# **Dutton Lane DA Submissions Report**

Development Application No. 664.1/2013

**Client:**  
Fairfield City Council

**Date:**  
24 March 2014

# A Height Variation Plan

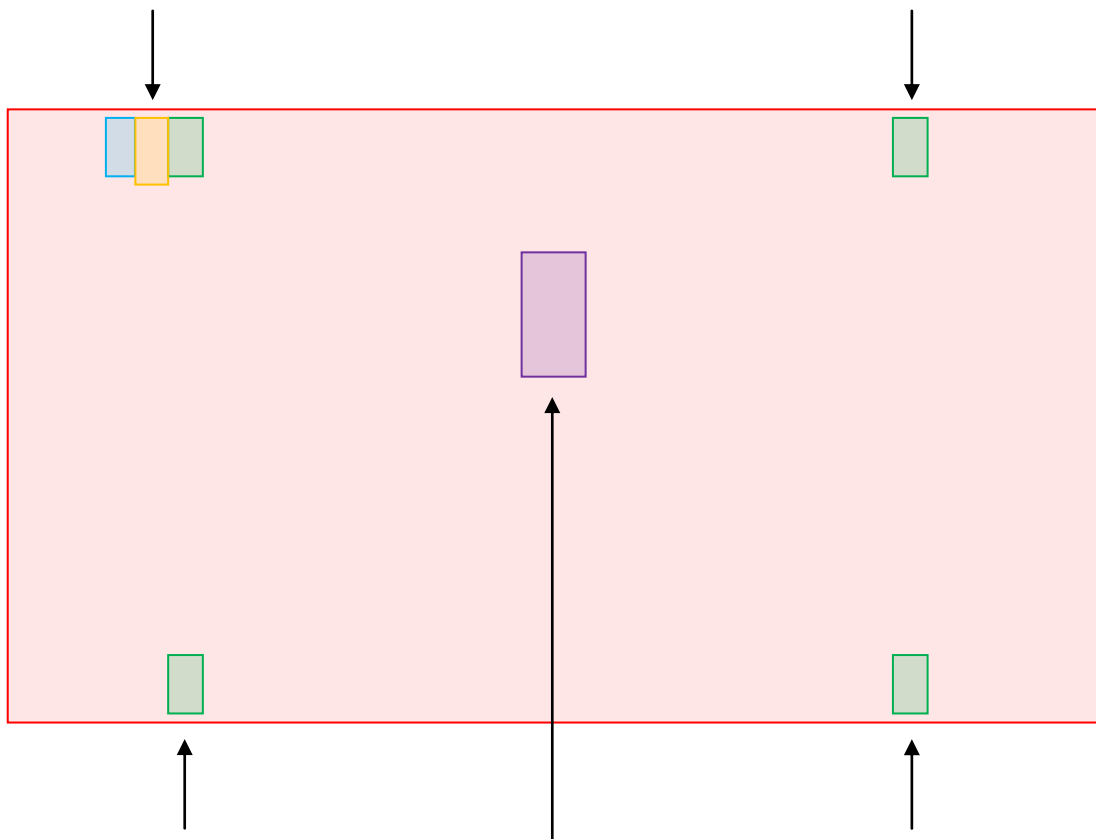
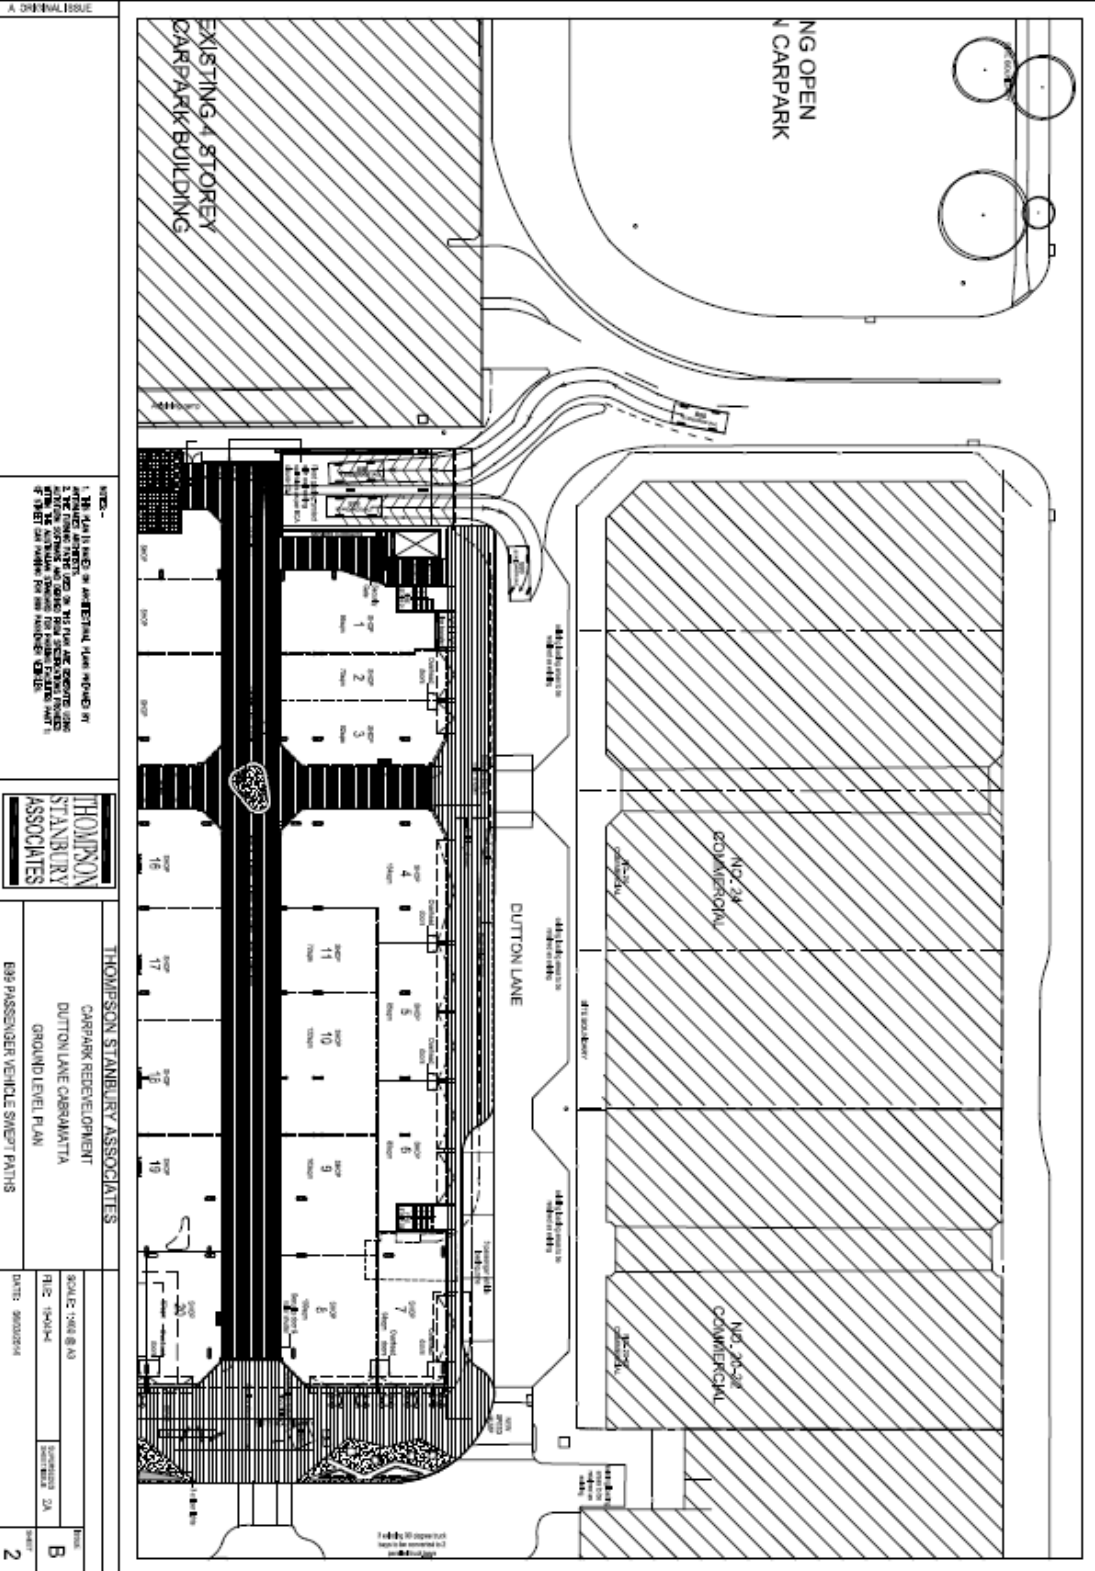
» Open space provision	<p>Lack of justification for the significant reduction in open space provision.</p> <p>Does not comply with DCP5 in relation to building height which requires the provision of 50% landscaped open space for development over a height of 10m.</p>	<p>The Fairfield LEP 2013 height of buildings controls state that the maximum permissible building height for the land is 16 metres. Notwithstanding, the LEP also states that the height of buildings should not exceed 10 metres unless at least 50% of the site area will be landscaped open space.</p> <p>The intent of these LEP clauses is to ensure that any major redevelopment of the site (which creates buildings of up to 16 metres in height – equivalent to 5 storeys) provides adequate open space in</p>

Issue	Details	Proponents Response
	<p>The Clause 4.6 variation may not be justified as the variation may not be in the “public interest”.</p>	<p>return for an increase in floorspace</p> <p>The Fairfield LEP 2013 also contains provisions (clause 4.6) that provide an appropriate degree of flexibility in applying certain development standards.</p> <p>The SEE seeks approval for a clause 4.6 variation as part of the proposed development. <b>Appendix A</b> illustrates the non-compliances. It is noted that only very minor variations to the building height controls are proposed, relating only to the fire stairs, lift core and plant room.</p> <p>The design of the structure has intentionally increased the height of the concrete fire stairs so as to add architectural interest to the building. Whilst a reduction to the height of the fire stairs and lift core could be undertaken to bring the proposal below 10 metres, it is considered that the proposal as exhibited presents an improved visual / architectural outcome. It is also noted that the non-compliance is limited to small parts of the building footprint as shown in <b>Appendix A</b>.</p> <p>The added height does not increase provide additional usable floor space or contribute to the leasable area of the development.</p> <p>The justification for the Clause 4.6 variation is considered sound. On this basis, it could be argued that the development is not required to provide any open space and such would typically be the case if the site was privately owned and developed.</p>

Height non-compliance is thus:

- 850mm in the area shaded green
- 850mm in the area shaded blue
- 100mm in the area shaded yellow

Height non-compliance is thus  
1,145mm in the area shaded green

Height non-compliance is thus  
150mm in the area shaded green.
